# SCHWEIZER SERVICE BULLETIN

C1B-019.1\*  
29 Jan 2007

**SUBJECT:** TAIL ROTOR SWASHPLATE BELLCRANK ASSEMBLY SAFETY WASHER  
INSTALLATION

**MODELS AFFECTED:** All 269C-1 Model Helicopters serial numbers 0001 thru 0266.

Figure C1B-019-1 Tail Rotor Transmission

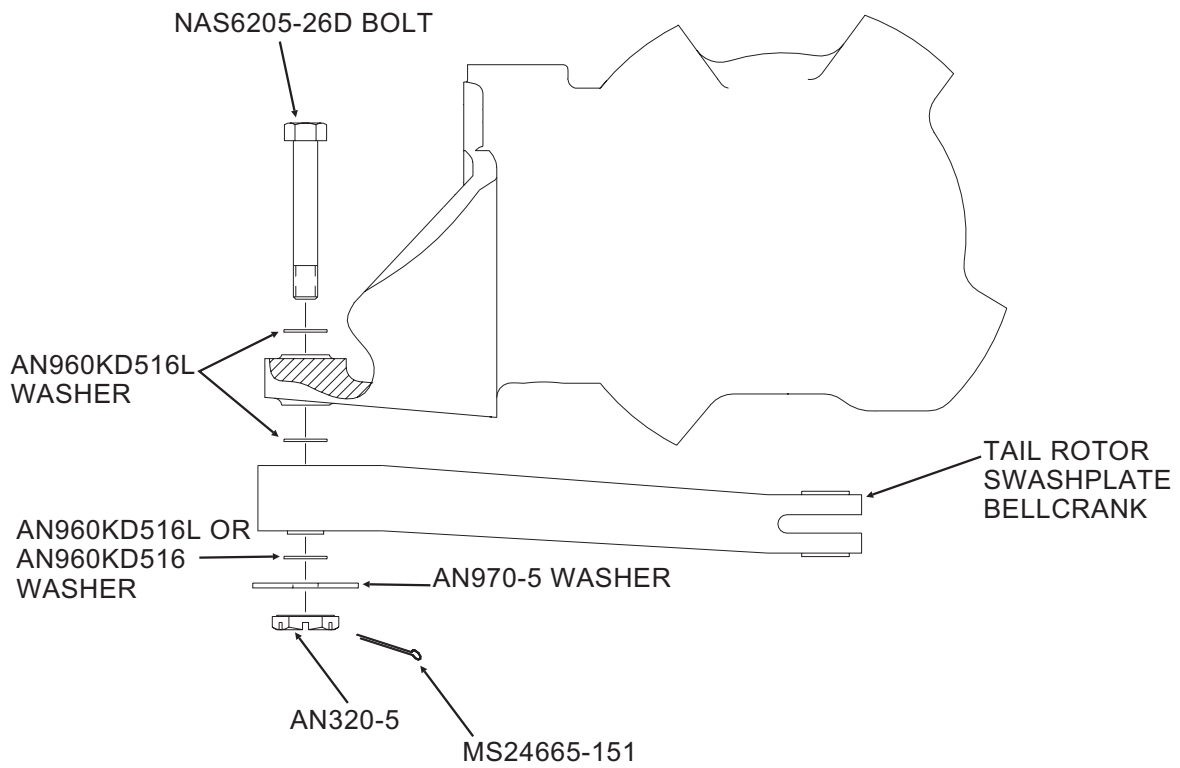
- PREFACE:**
- A report has been received of loss of tail rotor control due to deterioration of a tail rotor swashplate bellcrank attachment bearing. This allowed a downward displacement of the bellcrank to a point that the bellcrank pivot pin disengaged the tail rotor swashplate pivot bearing. Installation of a large area AN970-5 washer as a safety washer will prevent a bellcrank displacement that can cause pivot pin disengagement. 269C-1 Model Helicopters serial number 0267 and subsequent have been delivered with the large area washer installed.
  - Failure to comply with this Service Bulletin may lead to loss of control of the helicopter and subsequently cause serious injury, death and/or property damage.

- Inspect attachment bearing in tail rotor swashplate bellcrank assembly for security and condition in accordance with Basic HMI Section 9.
- Remove tail rotor swashplate bellcrank assembly from tail rotor transmission mount and discard NAS6205-25D bolt. Install bellcrank using NAS6205-26D bolt, AN970-5 large area washer, AN320-5 nut and MS 24665-151 cotter pin. Use AN960KD516L or AN960KD516 washers as required to shim for clearance between bellcrank and transmission mount and AN970-5 washer as shown in Figure C1B-019-1.
